City of Detroit  
Inter-Departmental Communication

**RE:** Petition No. 639  
Request Outright Vacation Of The Alleys In The Block Bound By Ellery, Garfield,  
Mt. Elliott, and Canfield

B					REQUEST TO OUTRIGHT VACATE VARIOUS PUBLIC ALLEYS, VARIOUS WIDTHS BOUND BY ELLERY ST., GARFIELD AVE., MT. ELLIOTT AVE., AND CANFIELD AVE.	CITY OF DETROIT CITY ENGINEERING DIVISION SURVEY BUREAU
	A					
DESCRIPTION		DRWN	CHKD	APPD	DATE	JOB NO. 01-01 DRWG. NO. X 639
DRAWN BY SA		CHECKED KSM		DATE 01-14-19		
REVISIONS						
APPROVED

**Detroit Water & Sewerage Department  
Requirements and Provisions for Petition No. 639**

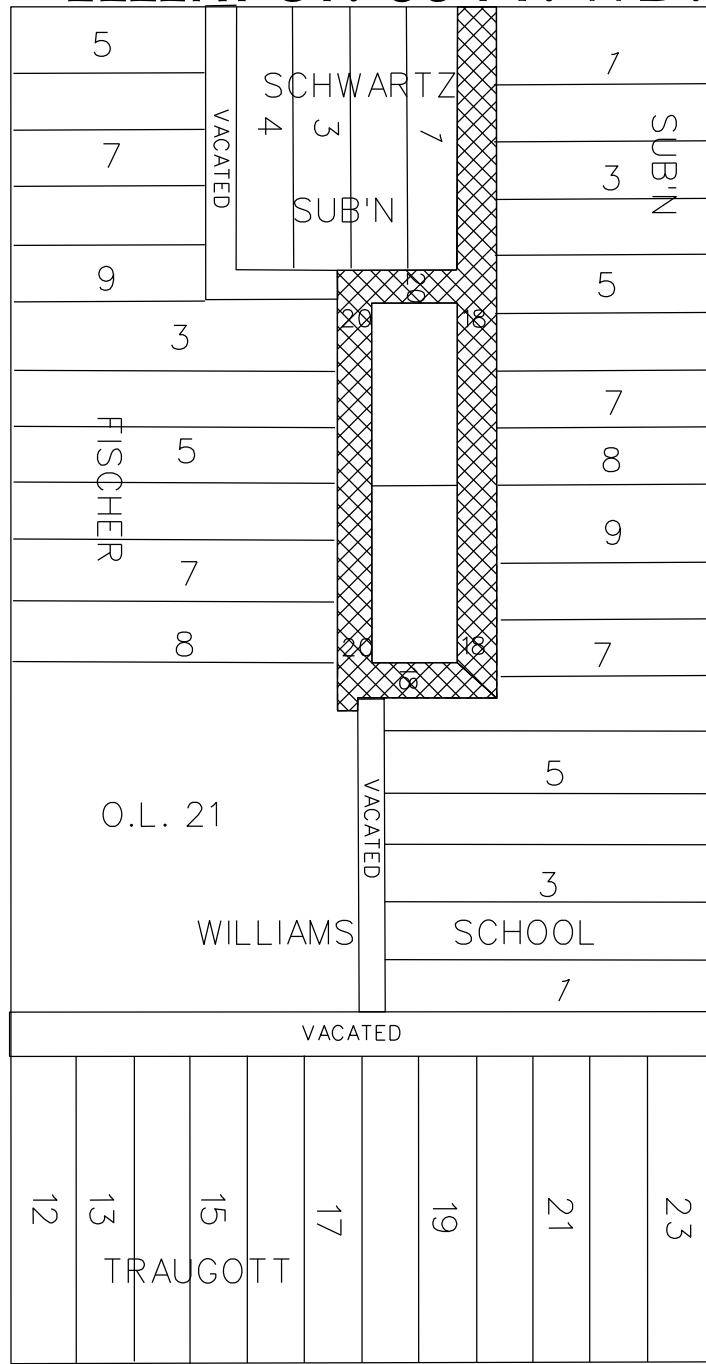
The Detroit Water and Sewerage Department (DWSD) is in receipt of the subject petition. There are sewers located in the alleys. DWSD has no objection to the requested vacation provided that the following conditions are met:

- The sewers service no other properties and only services the properties owned by the Petitioner, and there are no connections to sewers in Ellery affected, if not the Petitioner must prepare a relocation plan for the sewer signed by a Registered Engineer, DWSD approves the relocation plans, and the Petitioner grants a satisfactory easement for the relocated sewer. The Petitioner is to bear the entire cost of the proposed relocation plans, including construction, demolition, permitting, inspection, survey, etc.
- If DWSD is to maintain ownership of the existing sewer a satisfactory easement is to be granted by the Petitioner.

The entire work is to be performed in accordance with DWSD specifications and standards, all of the fees are to be deposited with DWSD in advance, to cover the necessary costs of permits and inspection.
